Comment by Emiliy Wade

Comments on the above planning and listed building consent applications.

Toll House is a Grade II listed building located in a prominent position on Lindfield High Street. The building originally dates from the 15th – 16th century, possibly constructed as a cross wing to a larger medieval house sited to the south, which was later replaced. It was extended to its west, street facing elevation c.1630, at which time a substantial chimney stack was also added to the rear of the building. A lean-to addition was made to the rear of the building during the 18th century. The building was used as a toll house between 1803 and 1884, in association with toll gates placed across the adjacent road. The property has a rear yard which is partly occupied by a range of outbuildings along its southern edge, which are suggested to date from the first half of the 20th century, replacing earlier structures in this position.

The proposal is to reconstruct the party wall and the very corner of the wall and the neighbouring wall, as per Listing Wall Rebuild Location plan 56HS-011-P-40:

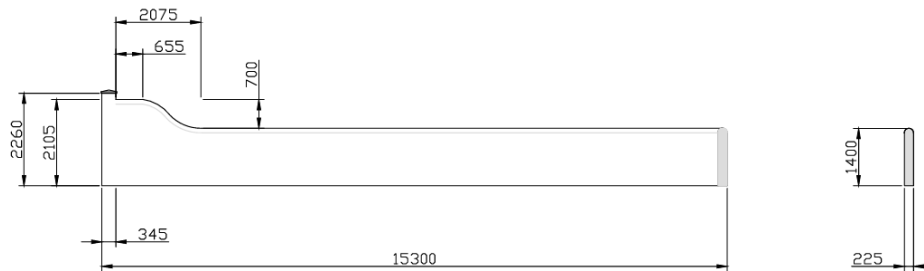
24. The proposed rebuilding of the brick wall is justified by a structural report which confirms the poor condition of the existing wall. The proposal is to rebuild the wall on a more or less like-for-like basis, saving the inclusion of weep holes and a differing corner detail, which are not considered contentious, although I do have a query stemming from the structural report. This states that to be structurally sound the wall can be reconstructed in the same manner as existing (i.e. a single brick in thickness) to a height of 1.35m, which is the height of the majority of the existing wall. However the front portion of the wall, adjacent to the High Street, is 2.05m high, and the plans suggest that the proposal is to also reconstruct this section to its existing height. Can the applicant please confirm that this is also a structurally sound detail?

All heights will remain the same. All stones of interest will also remain in the same locations.

The proposal is not to rebuild the neighbouring wall that fronts the High Street, simply to tie the corner in correctly at the party wall location.
